UNITED STATES PATENT AND TRADEMARK OFFICE

APPLICATION NO.	FILING DATE	FIRST NAMED INVENTOR	ATTORNEY DOCKET NO.	CONFIRMATION NO.
10/616,707	07/10/2003	Refaat S. Fanous	2682/102	1553

Office Action Summary	Application No.		Applicant(s)	
	10/616,707		FANOUS, REFAAT S.	
	Examiner		Art Unit	
	Michael J. Araj		3733

DETAILED ACTION

Figure 1

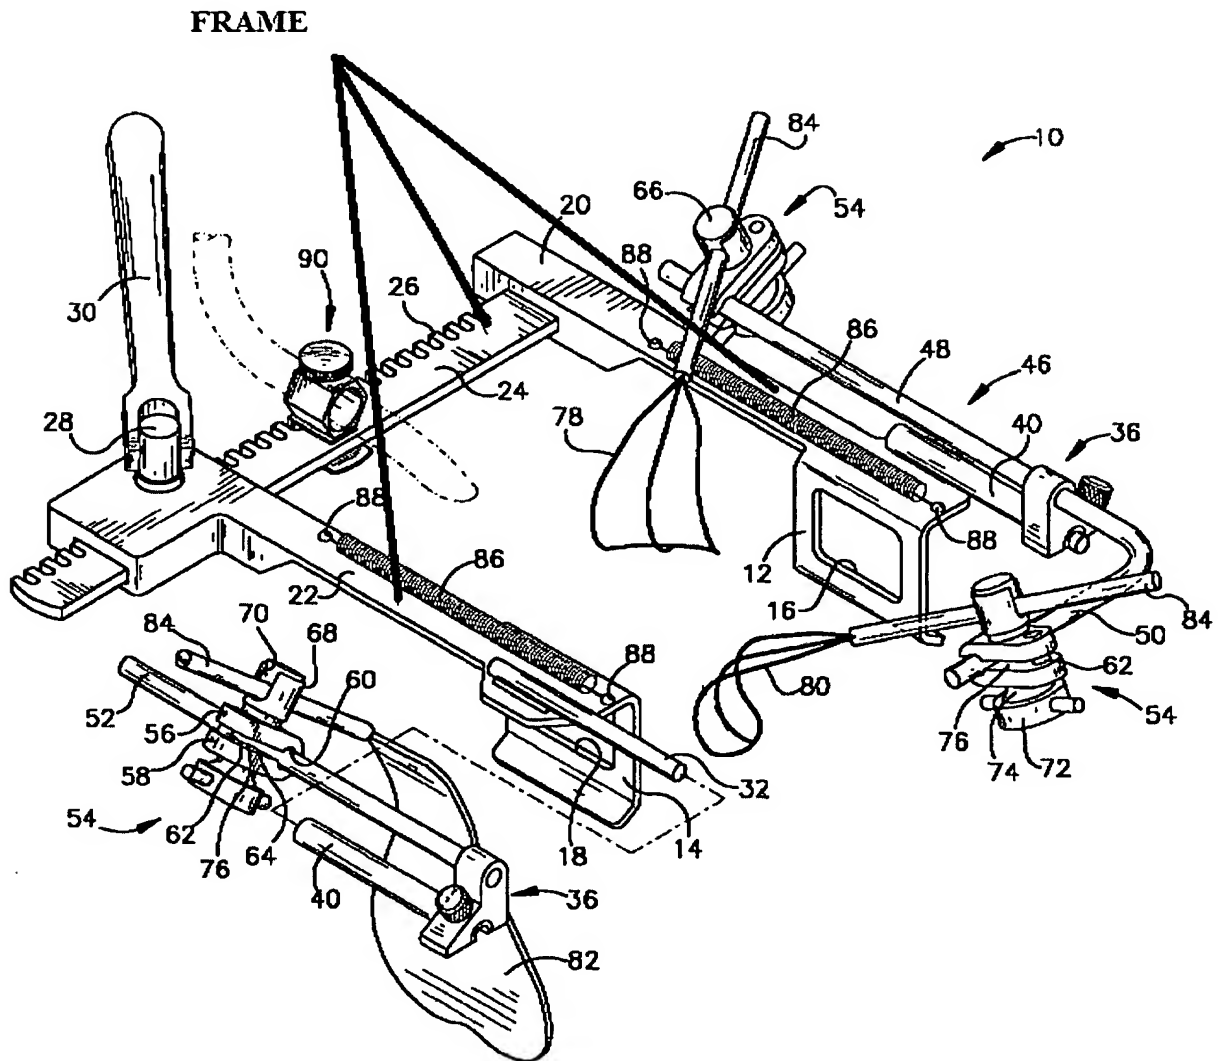
Claims 14, 16, 18, 23, 31, 33 and 37 are rejected, as understood, under 35 U.S.C. 103(a) as being unpatentable over Santilli et al. (U.S. Patent No. 6,099,468).

Santilli et al. discloses a retraction device (10) comprising a frame (see Figure 1 below) hinged (28) on a handle (30), where the frame includes a track (50) and at least one or more anterior retractors with a curved blade (78, 80, 82), attached to the retractor-handle (84) that is attached to the frame with a jig (54), where the retractor (10) is slidably mounted on the track (50) by a jig that does not contact the patient; a ratchet mechanism (26); and a support element (90) attached to the handle for retaining the device in a position. Santilli et al. discloses the claimed invention except for the frame being one-piece. Santilli et al. discloses the claimed invention except for the frame being one-piece. It would have been obvious to one having ordinary skill in the art at the time the invention was made to have made the frame of this invention one-

piece, since it has been held that forming in one piece an article which has formerly been formed in two pieces and put together involves only routine skill in the art. Howard v. Detroit Stove Works, 150 U.S. 164 (1893).

Figure 2

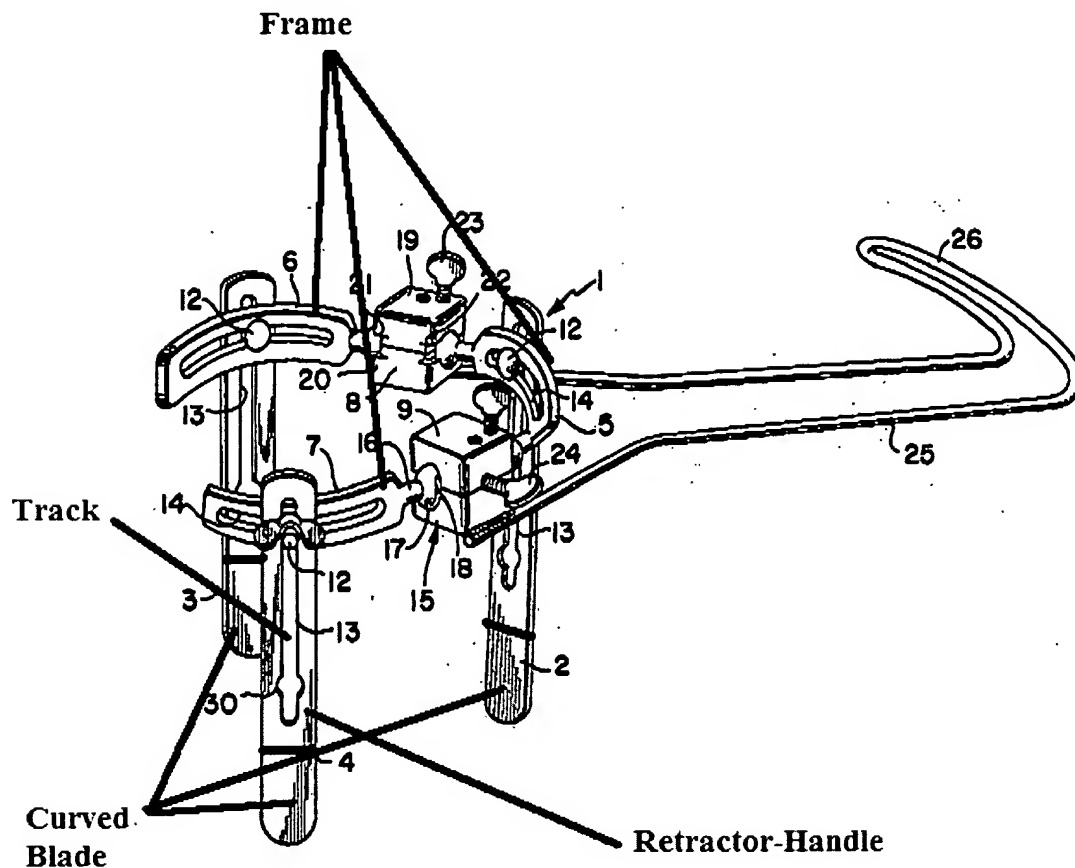
Claims 14, 16, 18, 20, 23, 31-34 and 40 are rejected, as understood, under 35 U.S.C. 103(a) as being unpatentable over Karlin et al. (U.S. Patent No. 3,509,873).

Karlin et al. discloses a retraction device (1) comprising a frame (see Figure 2 below) hinged (18) on a handle (25), where the frame includes a track (see Figure 2) and a least one or more anterior retractors with a curved blade (see Figure 2), attached to the retractor-handle (see Figure 2) that is attached to the frame with a jig (12), where the retractor is slidably mounted on the track by a jig that does not contact the patient; the track includes a groove/slot (14) for slidably mounting the jig (12) to the track; a support element (9) attached to the handle (25); a retractor-handle that has a groove along a portion of a length of it, where the groove (14) has a differential width (30); and the retractor is configured with a curved blade forming a groove capable of supporting another blade. Karlin et al. discloses the claimed invention except for the frame being one-piece. It would have been obvious to one having ordinary skill in the art at the time the invention was made to have made the frame of this invention one-piece, since it has been held that forming in one piece an article which has formerly been formed in two pieces and put together involves only routine skill in the art. *Howard v. Detroit Stove Works*, 150 U.S. 164 (1893).
